**Response to a Request for Further Information**

**Block R, Jordanstown Road, Aerodrome Business  
Park, Rathcoole, Co. Dublin**

South Dublin County Council Register Reference SD21A/0140

Figure 2.1: Extract from the Previously Proposed Site Plan (Left) and the Now Proposed Site Plan (Right)

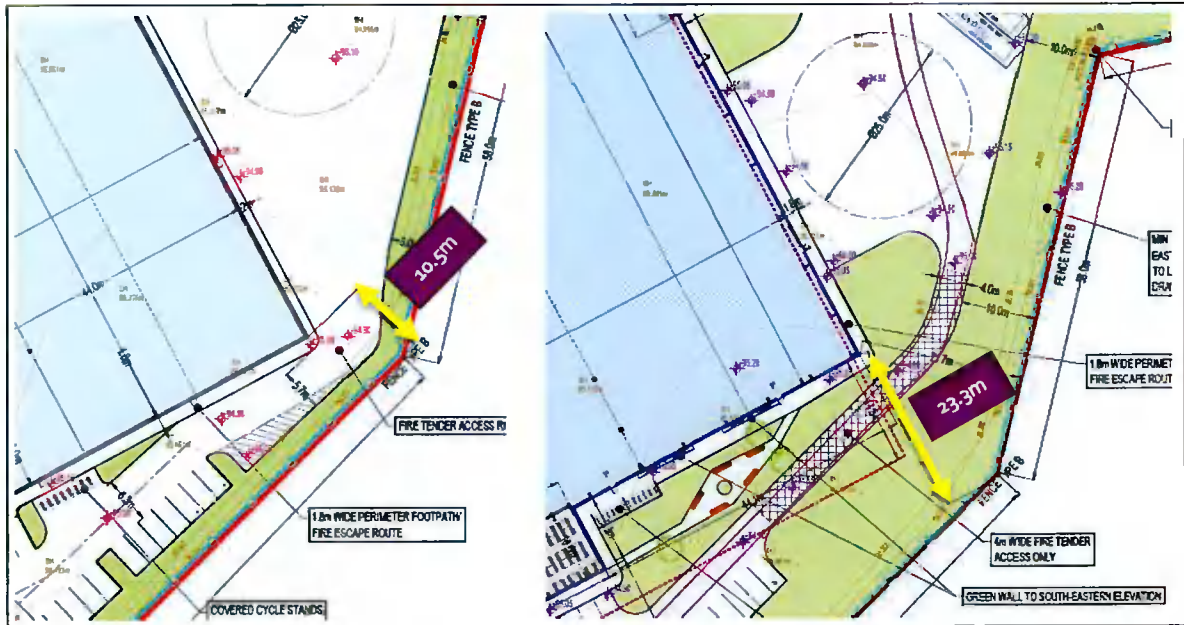
*The proposed warehouse at 22,966 sq.m, standing approximately 16 metres tall would be visible from the R120 on approach to Newcastle Village from the N7 (southern elevation). The subject site is located on the edge of the existing industrial area and interfaces with the rural area to the south and east. In this instance the Planning Authority considers that design proposals to transition the industrial area into rural lands should be introduced along the southern and eastern boundaries. The applicant is requested to submit revised drawings demonstrating the following:*

- 1. The relocation of the overall structure away from the southern boundary of the site (in a northerly direction)*
- 2. An increased natural buffer zone along the entire southern and south-eastern boundaries of the site, which shall include earthen berms and significant, increased planting. This is to mitigate the impact of the proposed development at this important interface.*
- 3. A redesigned southern façade of the structure should be investigated and submitted, which should include a complete change in proposed materials from that proposed for the warehousing element and should include a green wall/façade to enhance and complement the berm and increased planting required under item 2 above.*
- 4. Include CGIs of revised proposal*

Extracts from the Previously Proposed Site Plan and the Now Proposed Site Plan have been included below which show the relocation of the proposed warehouse structure away from the southern boundary in a northerly direction. An increase in the distance from the southern boundary is noticeable with an increase in the proposed separation distance to the boundary from 10.5m to 23.3m, as shown below:
